REVISION E CHANGES = **E** (1 CHANGES NOTED ON DRAWING)

DRAWN A. MCLAUGHLIN		HAVIS	
DATE	5/28/2014		
CUSTOMER APPROVAL (SIGNATURE REQUIRED):		TITLE LOW CONTOUR 8°-90°, WITH REAR LOCKING PLATE, CENTER HOLE SWIVEL STAND, ANTI-SKIMMING FEATURE, EMV CARD CLEARANCE, VERIFONE MX915	
DATE	SIZE C	DWG. NO. 367-3046	REV. E
		SHEET 1 OF 1

PIVOT MOUNT ASSEMBLY

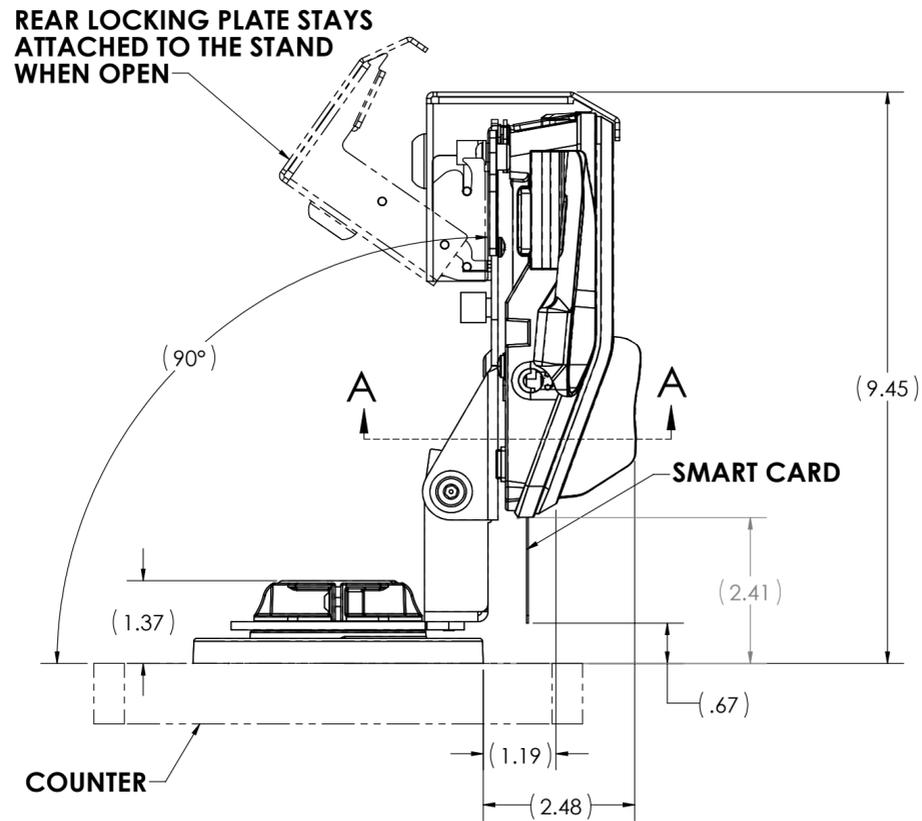
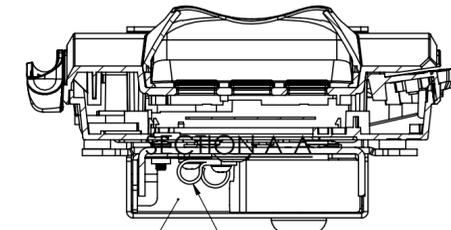
REV.	DESCRIPTION	DATE	BY	CHK'D
E	REVISED PIVOT MOUNT ASSEMBLY FOR IMPROVED PIVOTING PERFORMANCE REVISED PIVOT BRACKET FOR FIT AND FUNCTION WITH SMART CARDS. REVISED FIXED LOCKING BRACKET FOR IMPROVED FUNCTION, DIM 9.45 WAS 9.00, 2.41 WAS 1.96, 3.69 WAS 3.24, 6.42 WAS 5.97. ADDED SMART CARD, DIM .67	06/20/16	SCB	SCB
D	REVISED FIXED LOCKING BRACKET FOR BETTER FIT AND FUNCTION	12/08/14	JEB	SY
C	RE-DESIGNED PIVOT BRACKET FOR BETTER USE WITH SMART CARD. RE-DESIGNED FIXED LOCKING BRACKET FOR BETTER SECURITY. DIM 9.00 WAS 7.94, 1.96 WAS 2.18, 3.24 WAS 2.36, 5.97 WAS 4.80.	08/19/14	ZAG	AZM
B	RELEASE FOR PROTOTYPE	07/07/14	AN	SY
A	RELEASE FOR PROTOTYPE	5/28/14	AZM
